# USB Port Change Part

## Change list

# Internal Photo

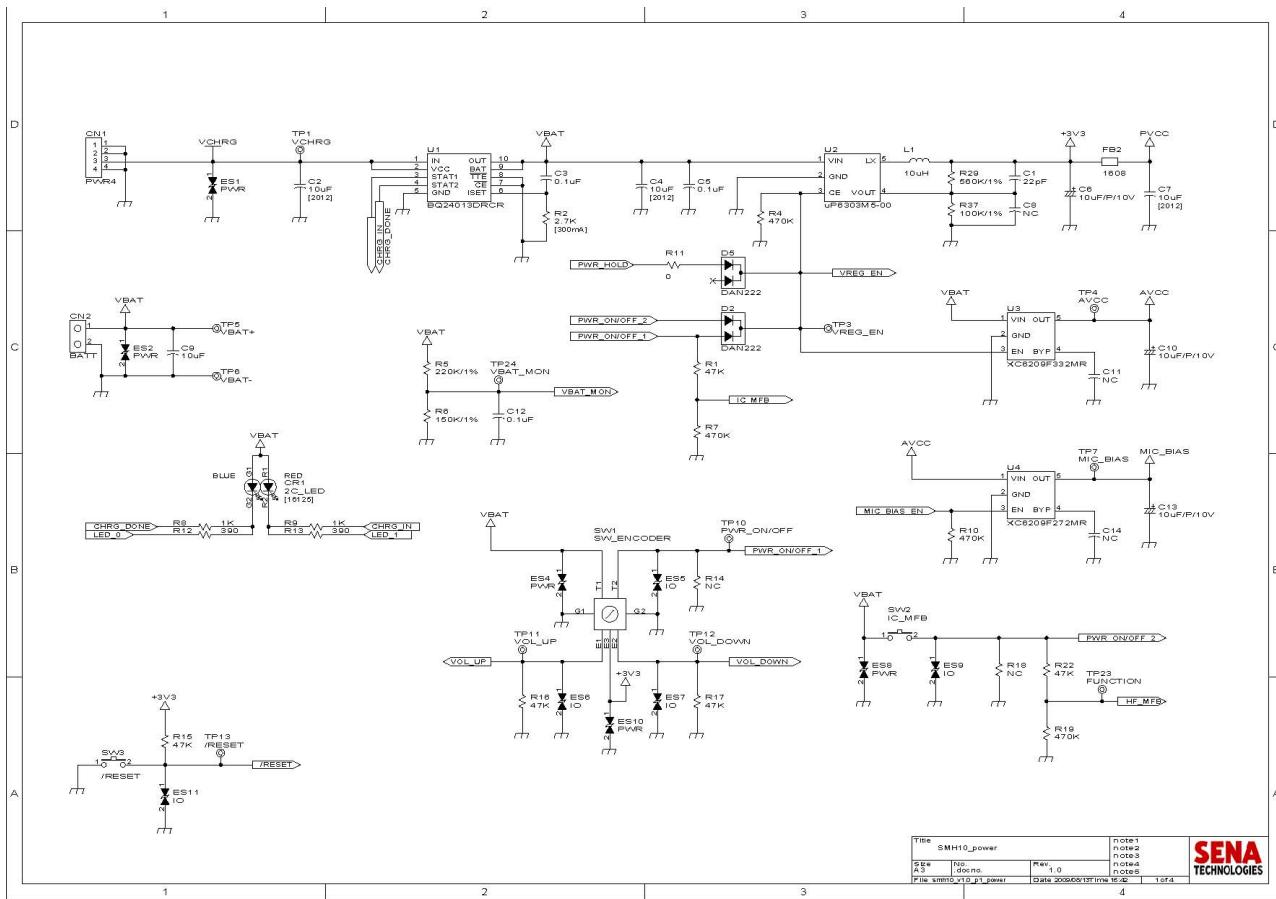
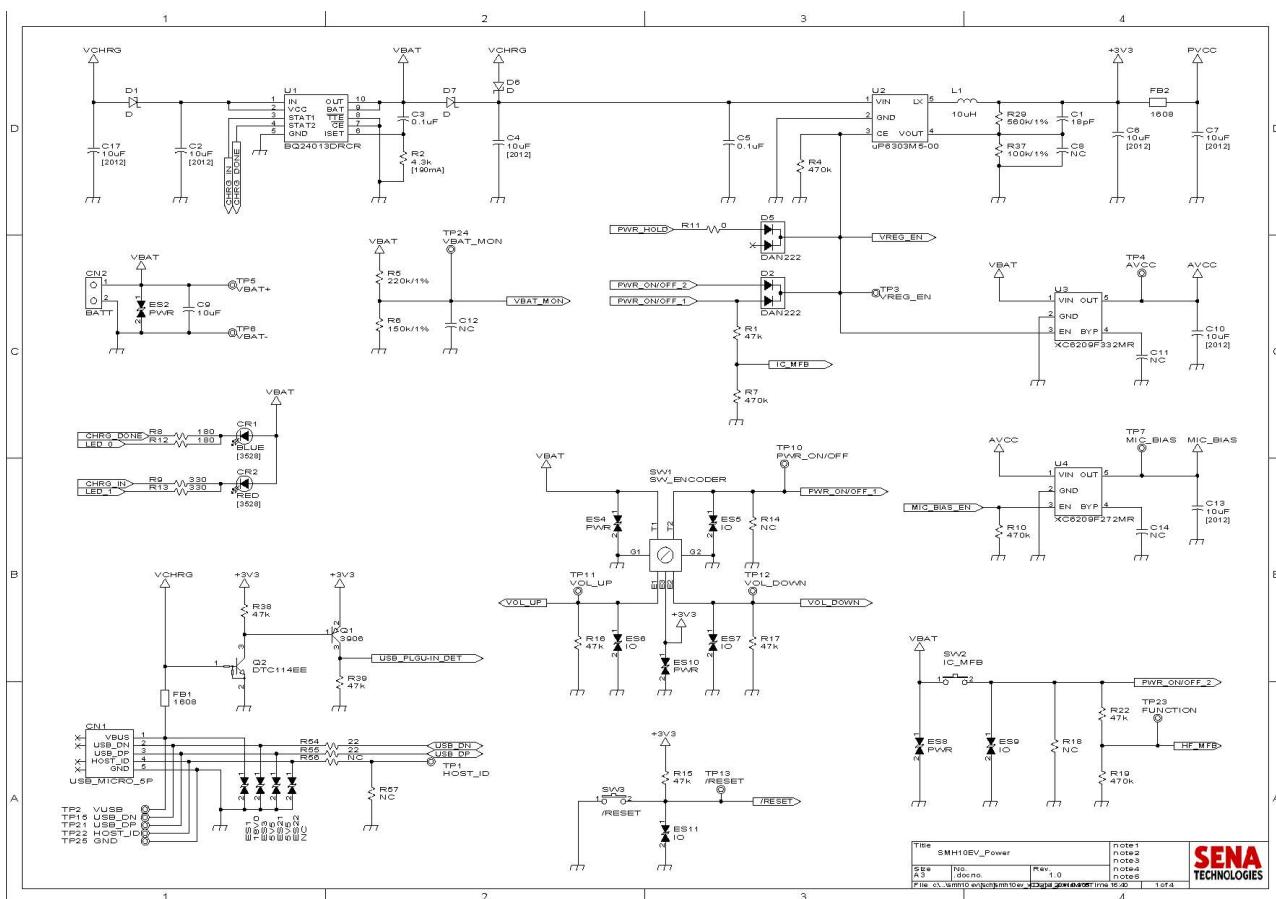
Before

After

## Before Schematic

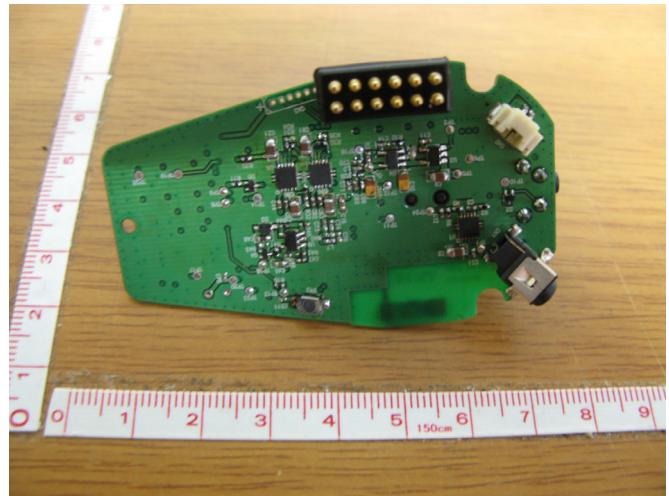
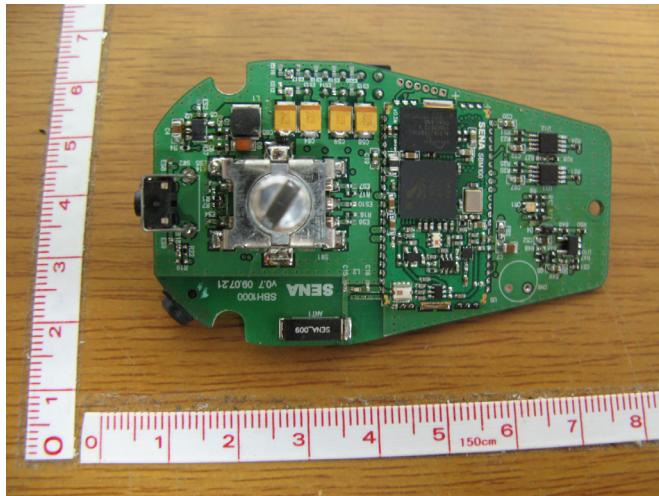
Item	before	after	비고
DIODE	-	D6,D7	ADD
Micro USB 5P	DC POWER JACK (CN1)	CN1	CHANGE
BEAD	-	FB1	ADD
NPN TR	-	Q2	ADD
PNP TR	-	Q1	ADD
RESISTANCE	-	R38, R39, R54, R55, R53	ADD
CONDENSER	-	C26, C27, C17	ADD
LED(BLUE)	DUAL LED	CR1	CHANGE
LED(RED)	DUAL LED	CR2	CHANGE
